Interested Party ref: 20049649

24 September 2024

Application by National Highways for an Order Granting Development Consent for the A46 Newark Bypass (TR010065)

Extract from drawing no. HE551478 Rev C01 Figure 7.4 Visual Receptor Plan.

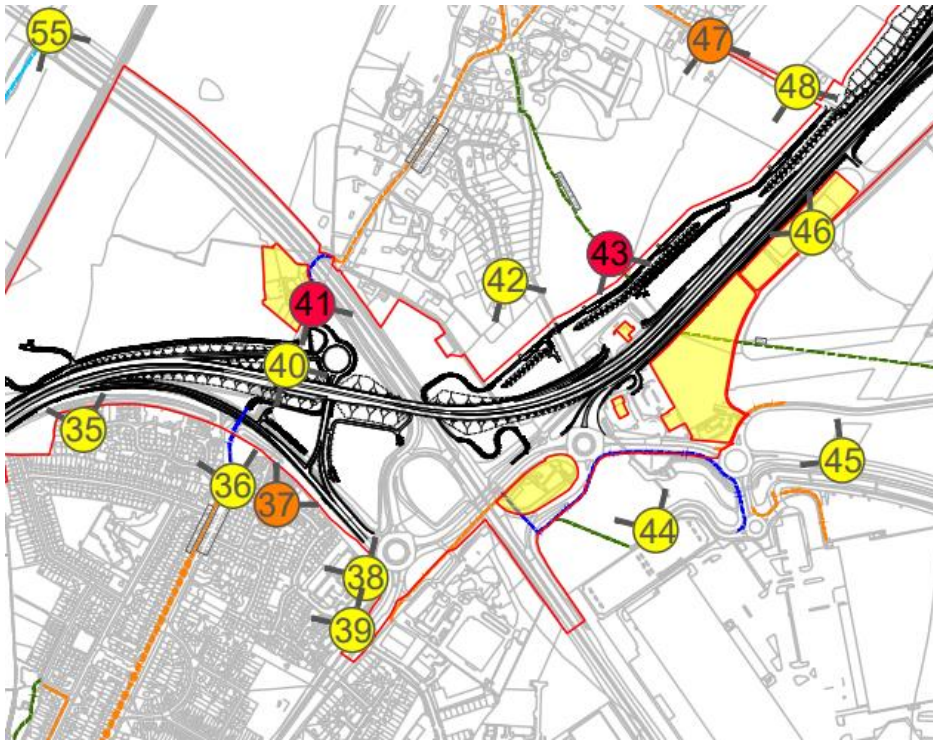
Following receipt of the Rule 6 letter dated 9th September 2024 and the Local Planning Authorities (LPA) subsequent registration for the Preliminary Meeting, I write to set out additional suggested locations for site inspections and if possible photomontages (at your discretion) in accordance with Procedural Deadline A within Annex D of your letter. The LPA welcomes your comments with regards to additional montages of viewpoint 18 (Newark Castle), 25 the approach into Newark Castle from the Cattle Market junction and photomontage 24 (Sandhills Park) and the additional work to VP11 (Farndon). However the LPA considers that there has been insufficient information showing the experience from within the Winthorpe Conservation Area and the effect of the new Brownhills junction and specifically the flyover, would have on it. Therefore we ask that you consider a visit and request a photomontage from the fields around VP42 or VP43 looking in a south westerly direction towards the new junction (see below). It is accepted that the site is heavily landscaped in this area and from the Arboricultural reports and plans, these trees are to remain. However the highly elevated position of the new flyover and the sensitive nature of the CA designation would mean that it is particularly vulnerable to change, especially by harsh infrastructure such as is proposed. VP43 which is along the existing footpath (Winthorpe FP2), the LPA does not agree that it effectively covers a sufficient area to be a true reflection of the actual impact, hence our request. The LPA will request this within our Local Impact Report also but we wanted to bring it to your attention at this early stage.
